**CITY OF RAMSEY LAND USE APPLICATION**  
**TECHNICAL REVIEW FILE**

<b>DATE</b>	04/03/2015	<b>PROJECT ADDRESS</b>	15153 NOWTHEN BOULEVARD
<b>PROJECT. TITLE</b>	HARVEST ESTATES		
<b>ESCROW #</b>	114538		
<b>DEPARTMENT:</b>	Community Development: Planning Division (Comprehensive Plan and Zoning Code)		
<b>PRIMARY CONTACT:</b>	Name: Tim Gladhill Phone: 763-433-9826 Email: <a href="mailto:tgladhill@cityoframsey.com">tgladhill@cityoframsey.com</a>		
<b>TECHNICAL REVIEW ASSISTANCE:</b>	Name: Tina Goodroad, AICP Phone: 763-496-6751 Email: <a href="mailto:tgoodroad@loucksassociates.com">tgoodroad@loucksassociates.com</a>

**General:** The purpose of this file is to review the official Preliminary Plat prepared by N.I.K. management on behalf of G S Land, LLC for the redevelopment for the former municipal campus located at 15153 Nowthen Blvd. NW as a 44-lot single-family residential development. The previous Sketch Plan review noted 45 lots. An existing lot along Helium Street has been removed, as it has already been subdivided as a buildable lot.

<b>DATE</b>	APRIL 3, 2015	<b>PROJECT ADDRESS</b>	WEST OF HELIUM STREET SOUTH OF 152 <sup>ND</sup> WAY
<b>PROJECT. TITLE</b>	HARVEST ESTATES PREL

### Interim Improvements

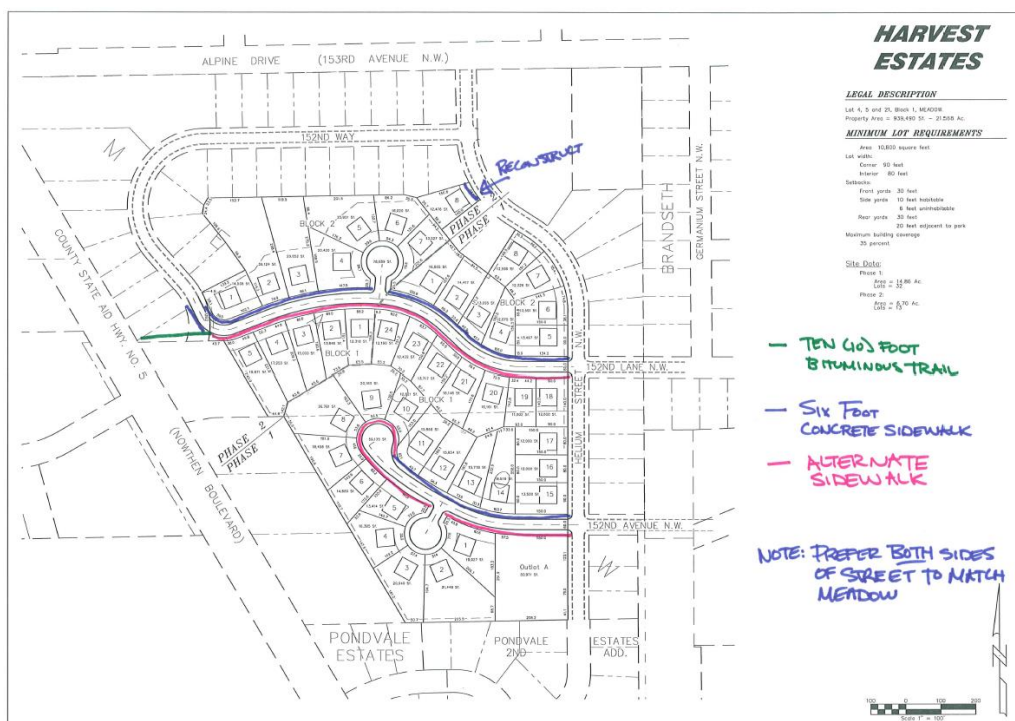
A portion of the northernmost proposed road is impacted by the phasing plan. This area is located near the former Police Department building. Staff recommends that the parking lot for this building serve as an interim turnaround due to the proposed schedule, as opposed to constructing a full-sized cul-de-sac. However, the plans show a full-sized cul-de-sac in the event Phase II does not commence construction in 2016. The Development Agreement and financial surety requirement shall address this staging issue to ensure the City can react as needed.

#### Phasing Plan

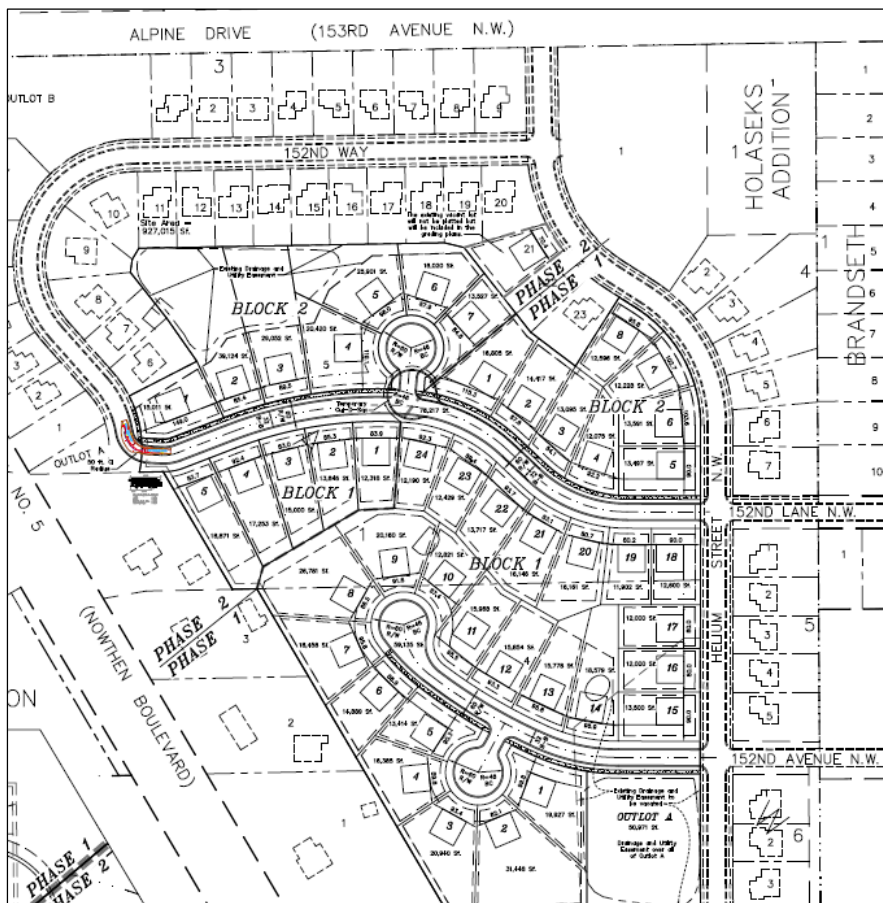
The Preliminary Plat contains 44 lots. It is anticipated that the project will happen in two (2) phases. Phase I is planned for thirty-two (32) lots. Phase II is planned for twelve (12) lots. Phasing is necessary to allow a portion of the project to move forward prior to the new Fire Station No. 2. Staff would like to explore an alternative phasing plan with the

Developer that would either 1) amend the scope of Phase I or 2) divide the project into three (3) phases. Regardless, Staff will support the current phasing plan as outlined in the Purchase Agreement. The intent of this section is to outline outcomes and alternatives now that additional design details are known that weren't available during concept and sketch plan review.

Only a portion of 152<sup>nd</sup> Lane (proposed Northern street) will be able to be constructed with the current phasing plan due to existing buildings. Interim Step #1 of the current phasing plan would utilize the existing parking lot for the former police station as a 'temporary cul-de-sac'. Interim Step #2 of the current phasing plan in the event of delay of Phase II would be to construct an actual cul-de-sac at the end of 152<sup>nd</sup> Lane for Phase I. As the Commission is aware, these 'temporary' cul-de-sacs can be challenging. There are ten (10) lots proposed on 152<sup>nd</sup> Lane in Phase I.

The benefit to the City would be to avoid a phased construction of 152<sup>nd</sup> Lane, avoiding construction staging conflicts and temporary cul-de-sac conditions. The benefit to the Developer would be a lower Financial Guarantee requirement and cost-savings in construction staging and reconstruction. The City's Subdivision Ordinance would provide the City the tools to require full cul-de-sac construction and associated rights-of-way. If the City were to require full cul-de-sac construction and associated right-of-way, two (2) lots would need to be removed from Phase I.
